Rulemaking 19-11-009 (Filed November 7, 2019)

THE PROTECT OUR COMMUNITIES FOUNDATION COMMENTS ON THE CALIFORNIA INDEPENDENT SYSTEM OPERATOR CORPORATION DRAFT LOCAL CAPACITY TECHNICAL ANALYSIS FOR 2021

Dated: April 17, 2020

Figure 2: SDG&E Historical Demand Curve for the Peak Day vs. CAISO 2021 Projection¹⁵

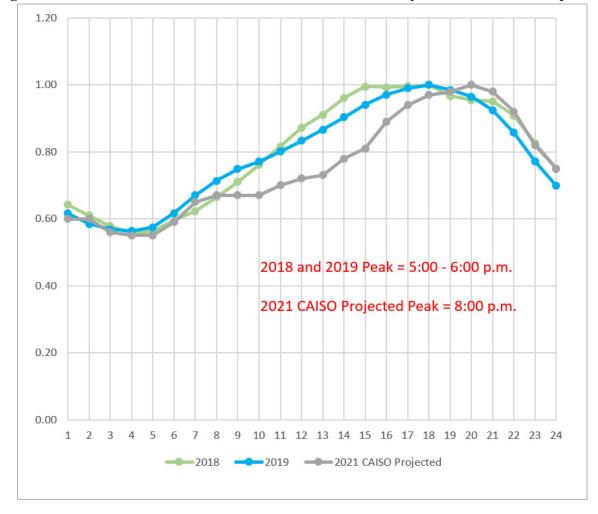
As noted in Figure 1, the hourly average peak demand in SDG&E service territory has never occurred later than the 5-6 p.m. hour during the last 5 years. Figure 2 shows that CAISO's projection shifts the peak demand hour a full two hours later than the latest historical peak demand. CAISO must provide a strong basis for such an unprecedented and dramatic shift in the peak demand window to justify its assertion that the peak energy use in the San Diego – Imperial Valley Area will occur at 8:00 PM.

Time of day projections have a big impact on the peak demand. First, the later in the day the peak occurs, the lower the demand will be. CAISO projected the peak net load for 2021 at 4415 MW.¹⁶ While 4415 is 8.5% higher than 2019's peak load, CAISO's projection is 15% higher than 2019's 8:00 p.m. demand on the same day.¹⁷ The magnitude of the difference between CAISO's projected peak and the 2019 historical load equates to the entire Planning Reserve Margin used to determine system RA need. CAISO's projected load is simply too high to be believable for an 8:00 p.m. peak. If the Final LCR Report has not corrected the overestimation of peak load, then SDG&E customers will pay for more peak load capacity than needed and they will also pay for more RA capacity than needed. CAISO must revise the Final LCR report to eliminate over-procurement and protect ratepayers from unnecessary costs.

Figure 3: CAISO system renewable energy production September 1, 2019¹⁹

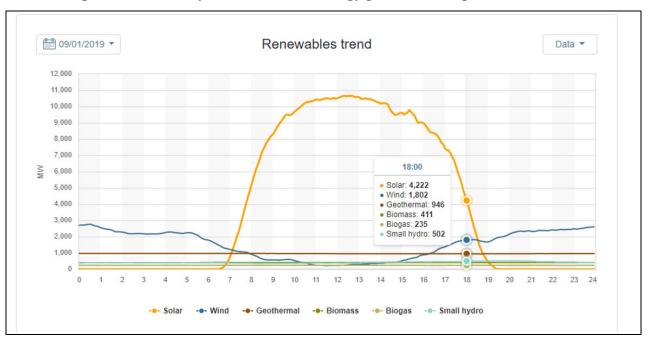
Second, if CAISO revises the peak from 8:00 p.m. to the historical peak between 5:00 p.m. and 6:00 p.m., then, all solar generators' contributions to serving peak load increase dramatically. The CAISO Draft LCR Report assumes the BTM contribution at 8:00 p.m. at 0 MW.¹⁸ However, even at the end of the 5:00 p.m. to 6:00 p.m. hour on September 1, 2019, solar was still producing at 39% of its peak capacity for the day. Figure 3 below details the change in contribution from solar resources depending on the time of day.

SDG&E produces 20% of its energy from in front of the meter solar.²⁰ An additional 1,260 MW of BTM solar contributes to a reduction in net load prior to sunset in SDG&E service territory.²¹ Thus, CAISO must either lower its peak demand projection for the 8:00 p.m. time due to dramatically lower historical use at that time of day, or the CAISO must lower its peak demand projection by revising the time of peak demand to earlier in the day when solar can - and does - serve peak load.
